**RE: Monte Vista Elementary School
3211 Monte Vista Dr. NE
Grading and Drainage Plan
Engineer's Stamp Date: 1/11/2022
Hydrology File: K16D017**

Based upon the information provided in your submittal received 1/4/2022, the Grading & Drainage Plan is **not** approved for Building Permit. The following comments need to be addressed for approval of the above referenced project:

DMP-00

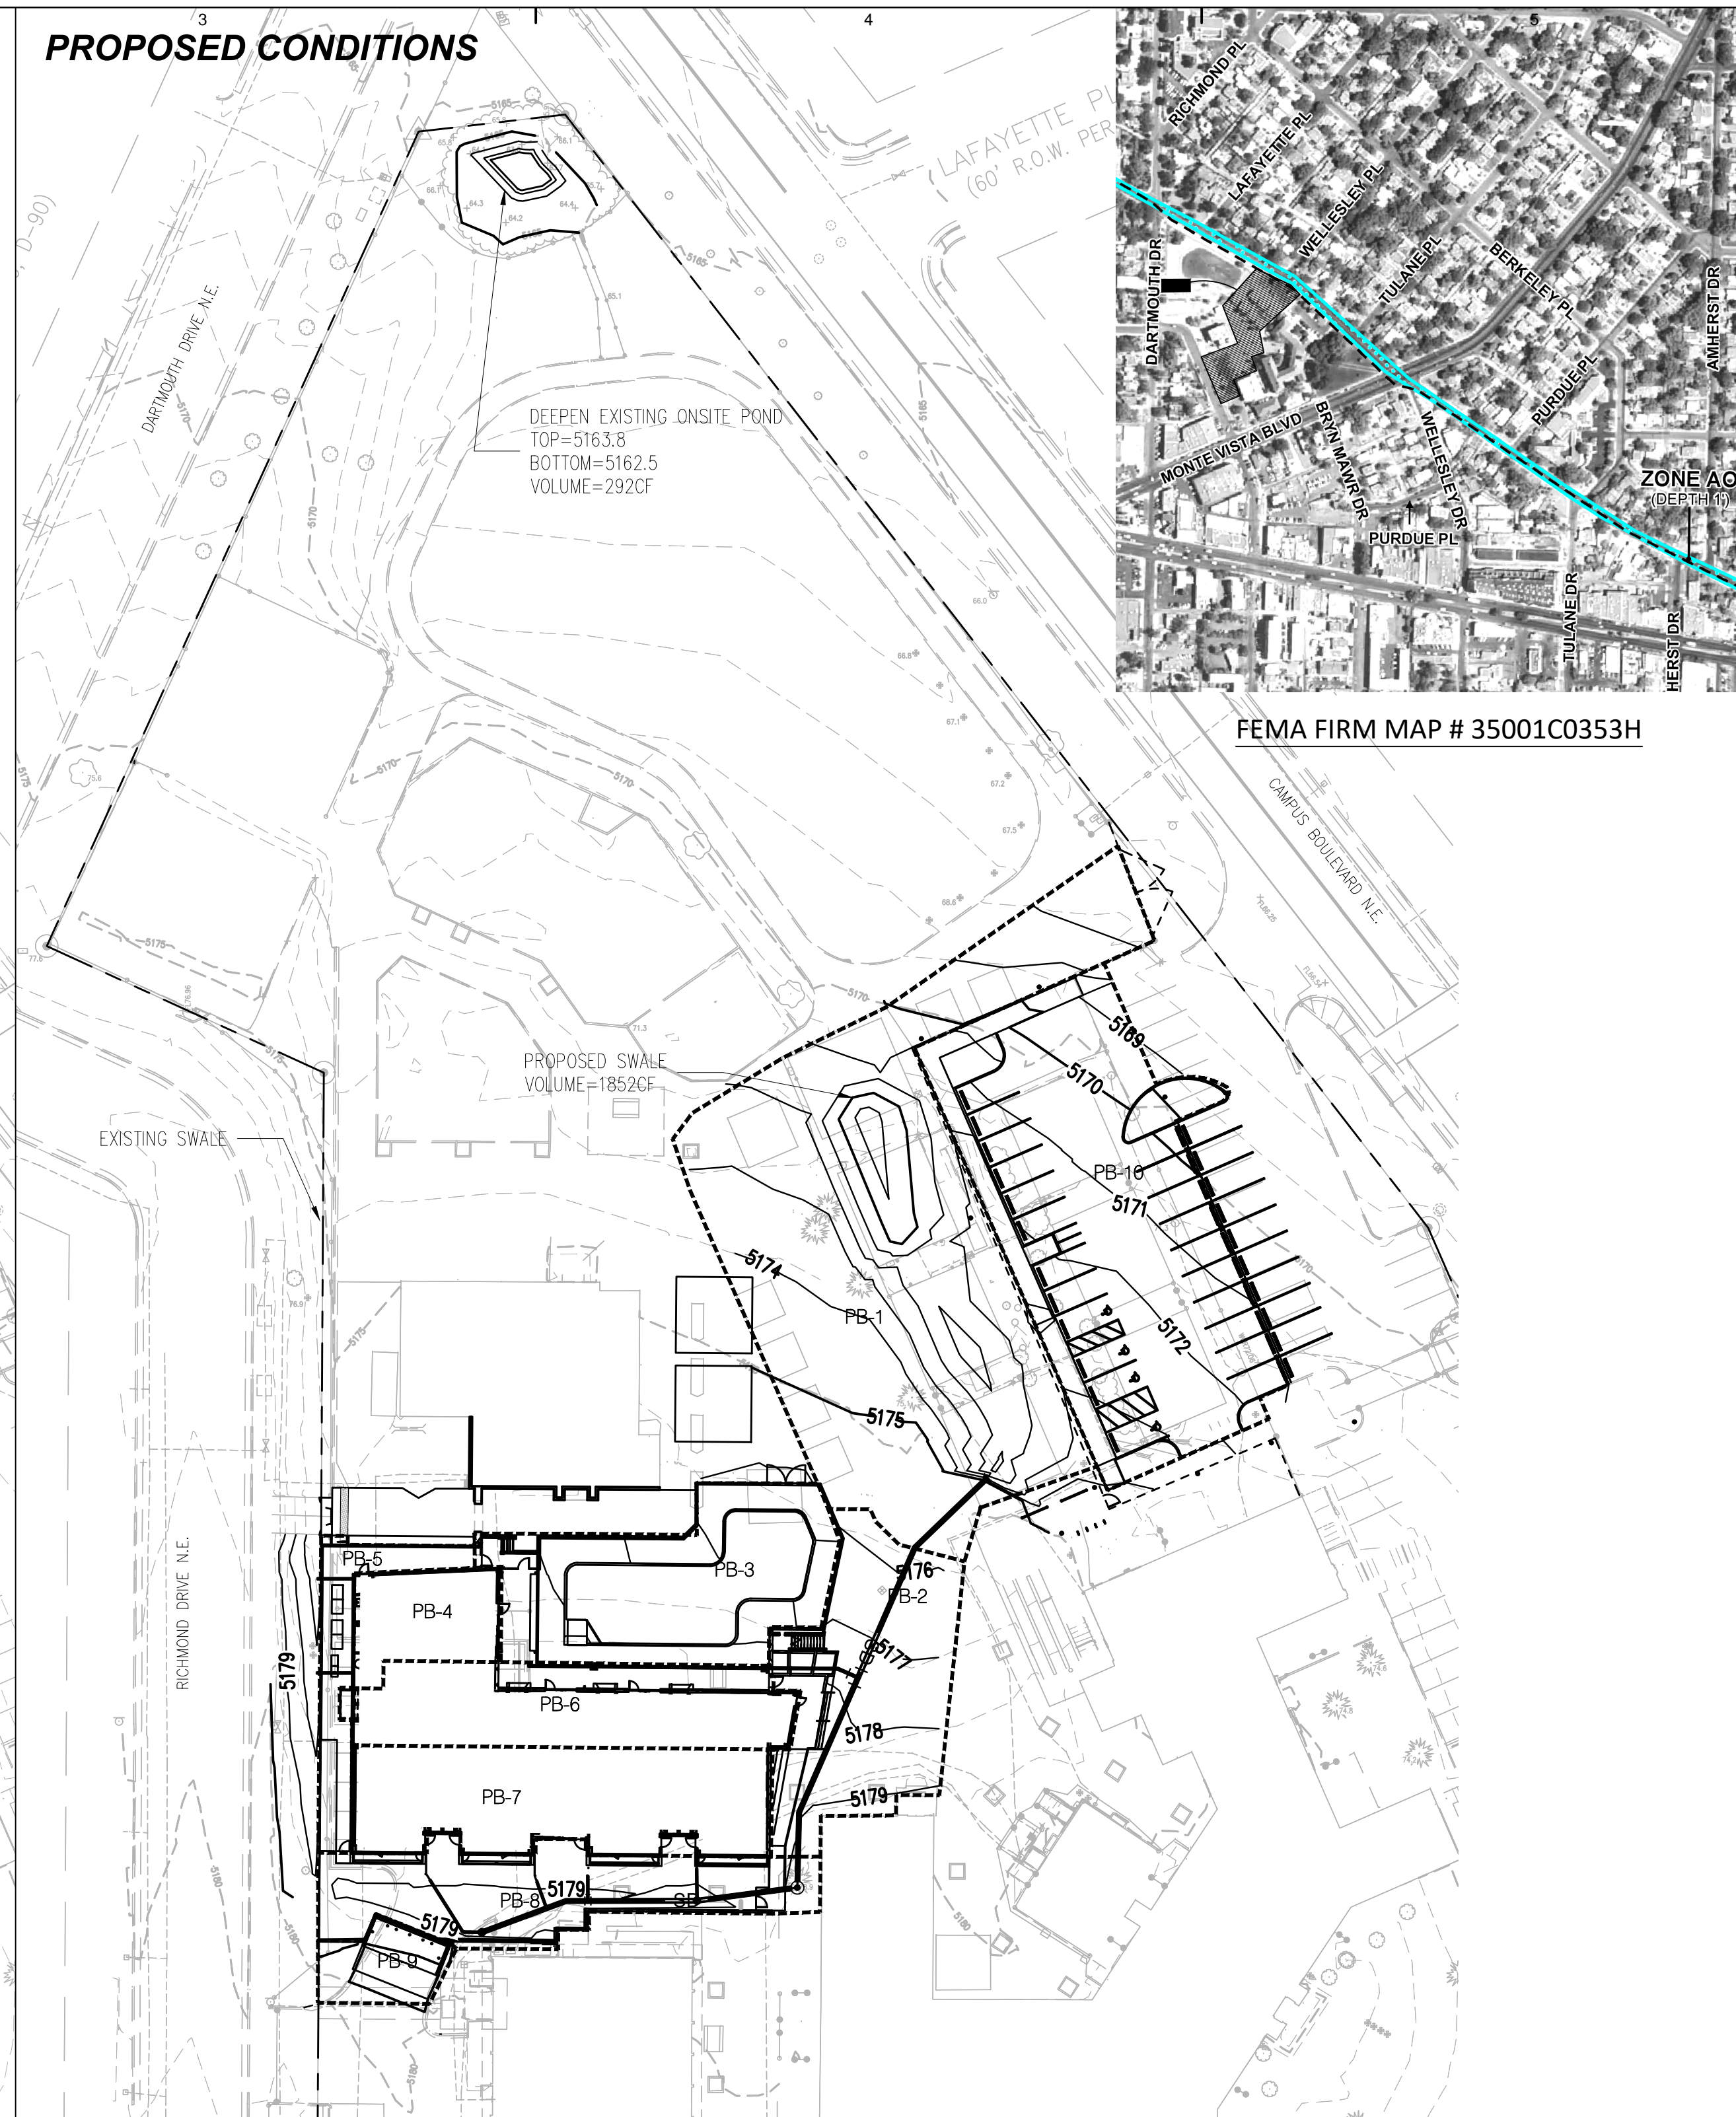
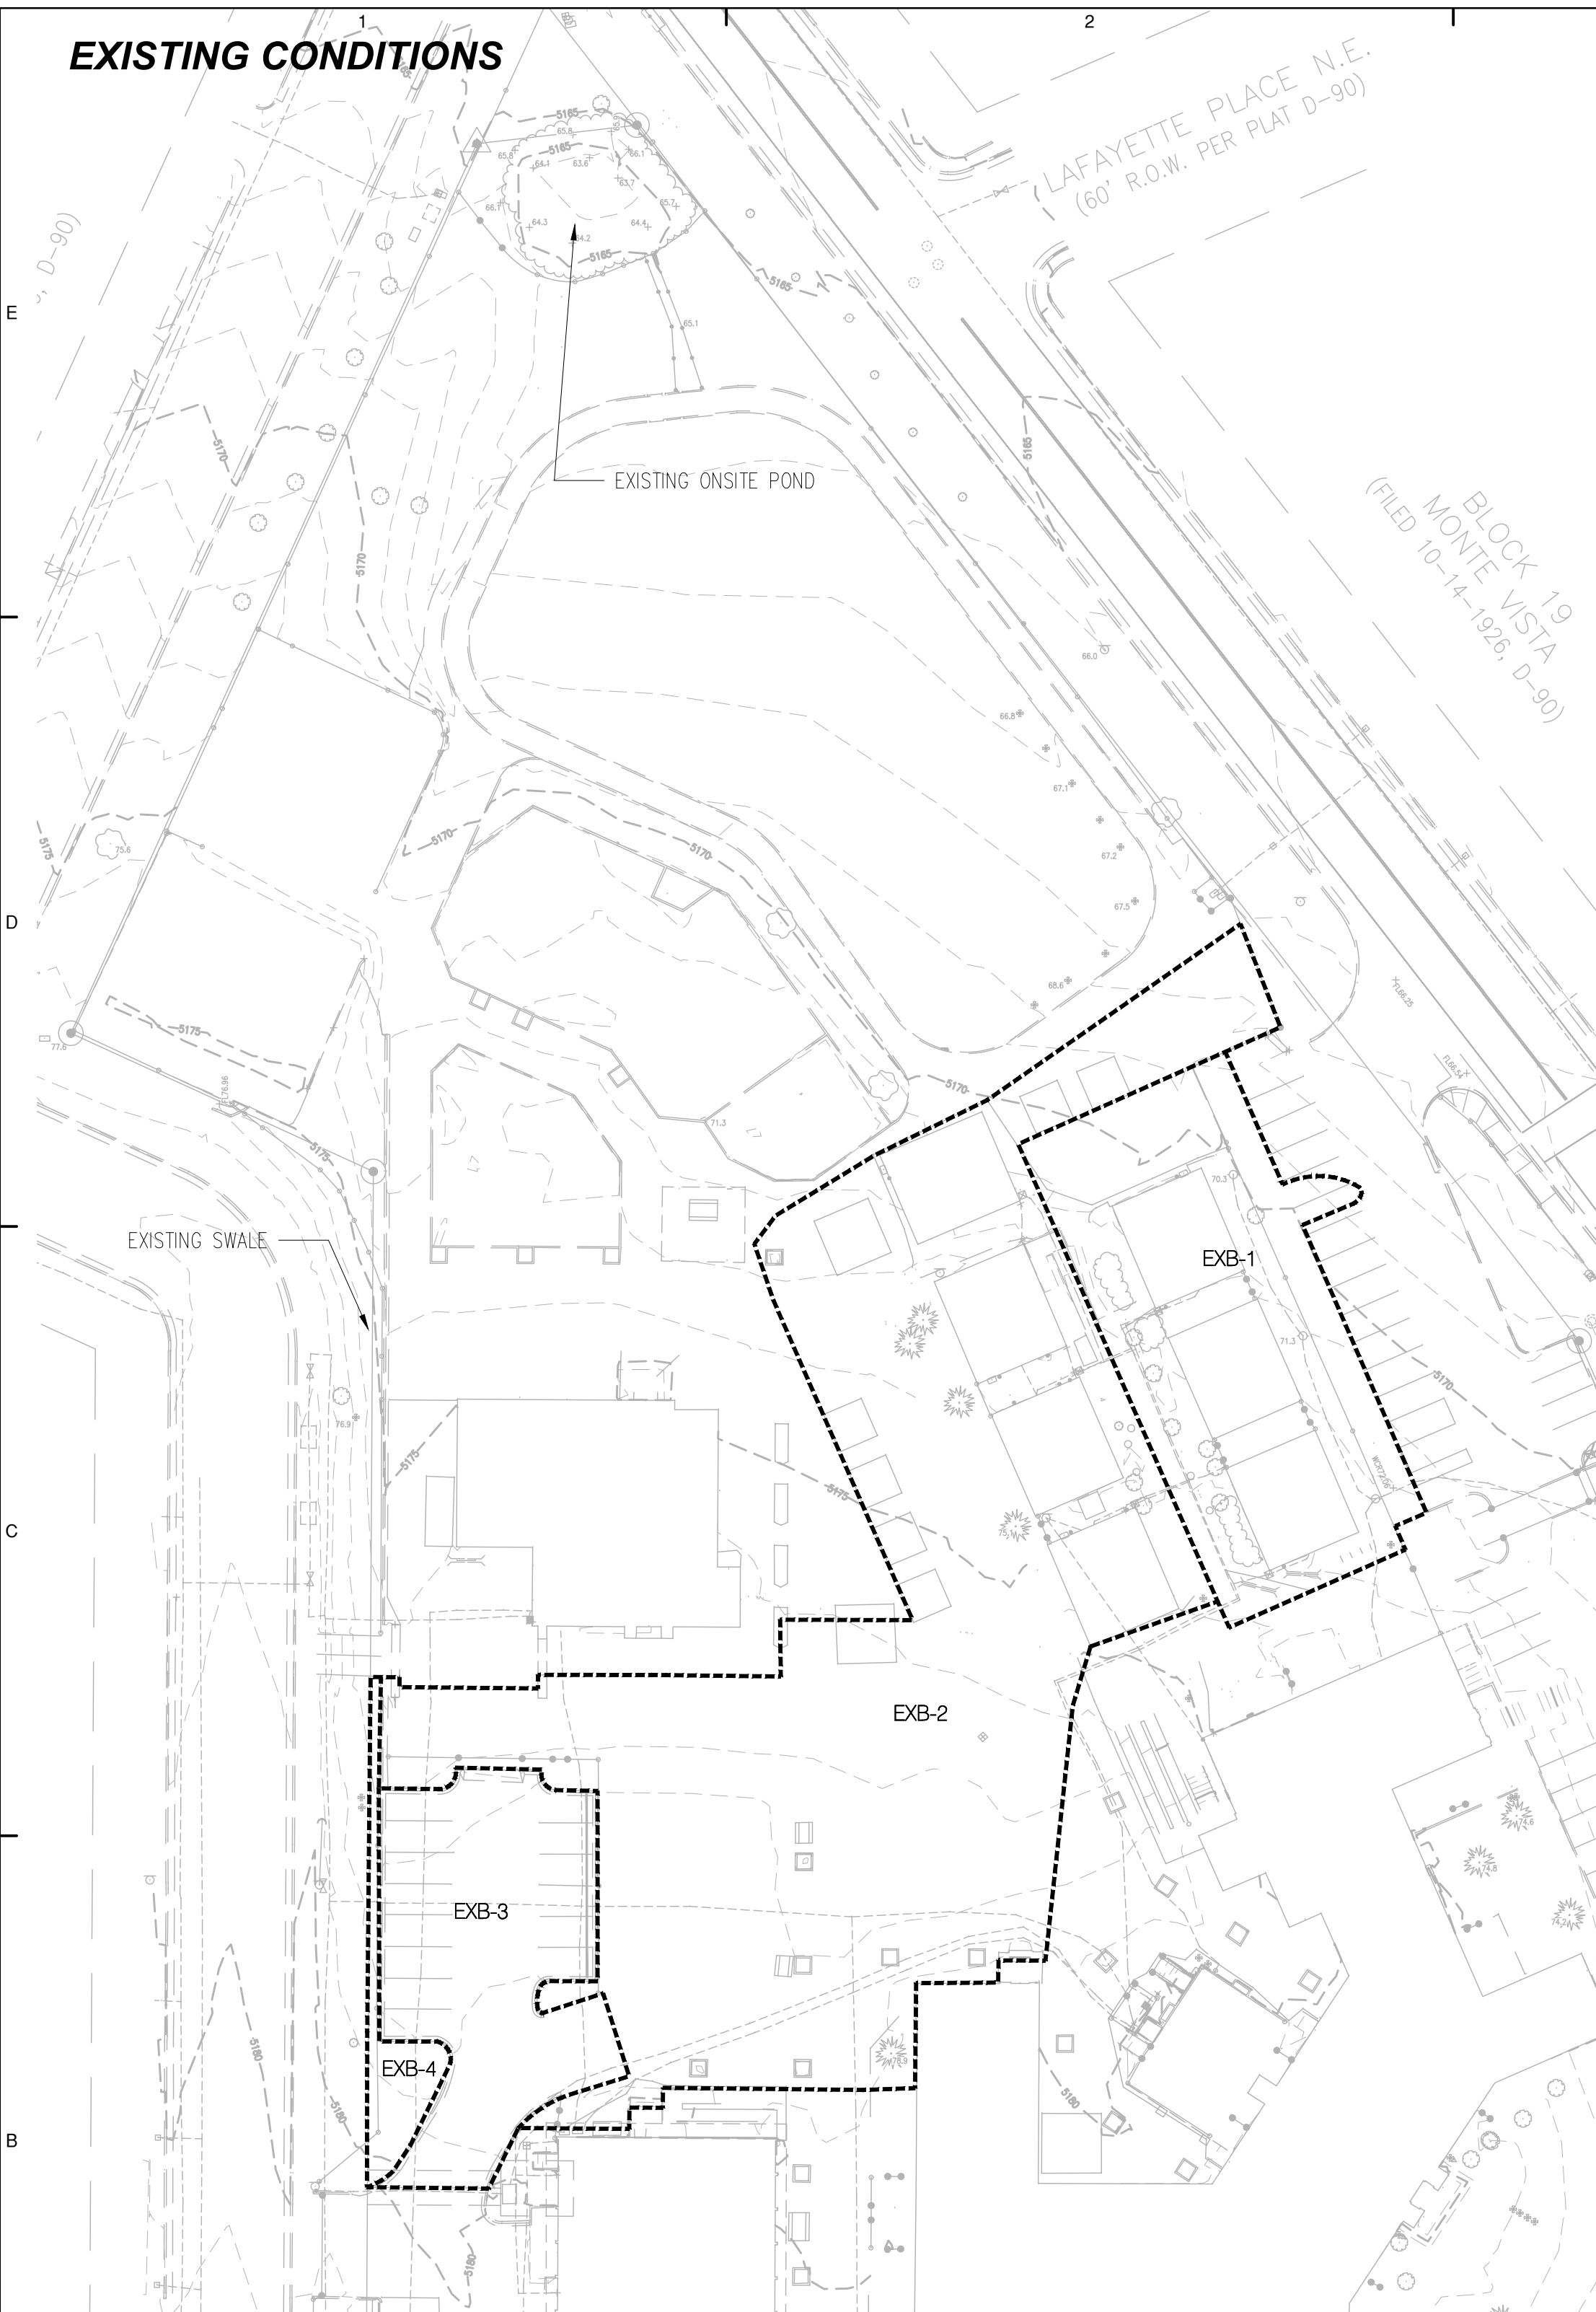
7. It is difficult to know what is being proposed vs what is existing. Is there any new pavement? If so show it.
8. Label all affected area and calculate what is proposed vs existing clearly in narrative.

9. Please calculate the water quality volume required (this will include the entire construction area that is affected/changed for redevelopment per DPM CH 6)

C-200

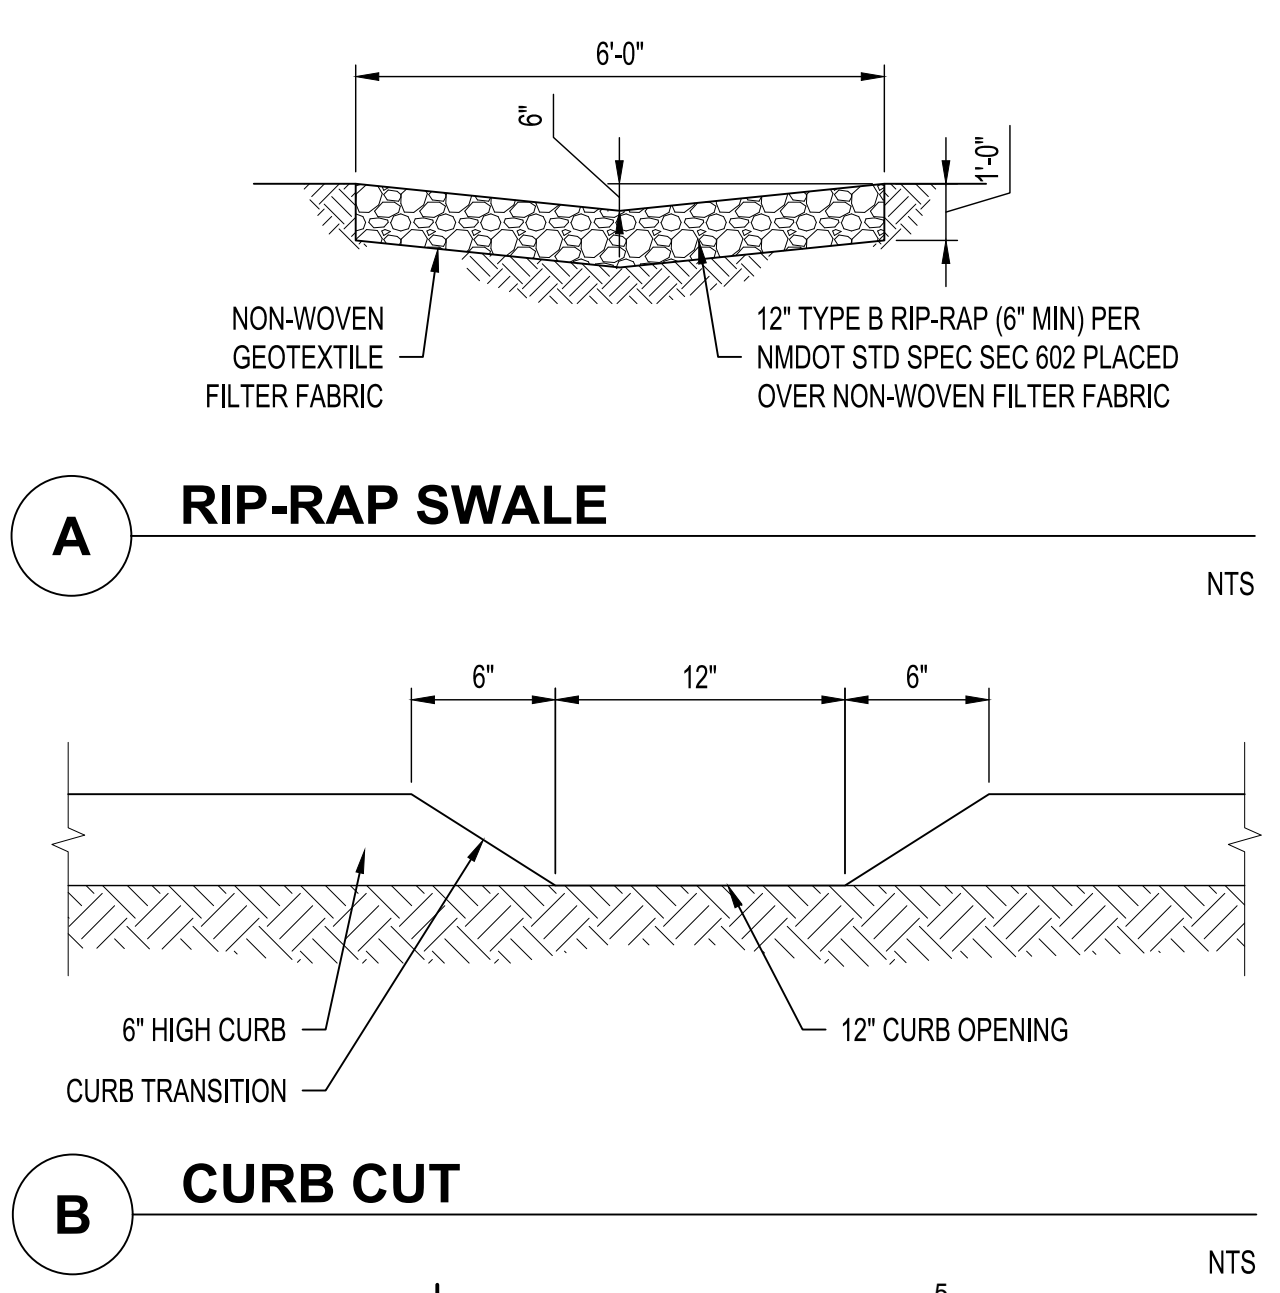
5. You are showing sections (A and B) on C-200 but do not show where these are on the site. Please show what location.
6. Clearly delineate the affected construction area.
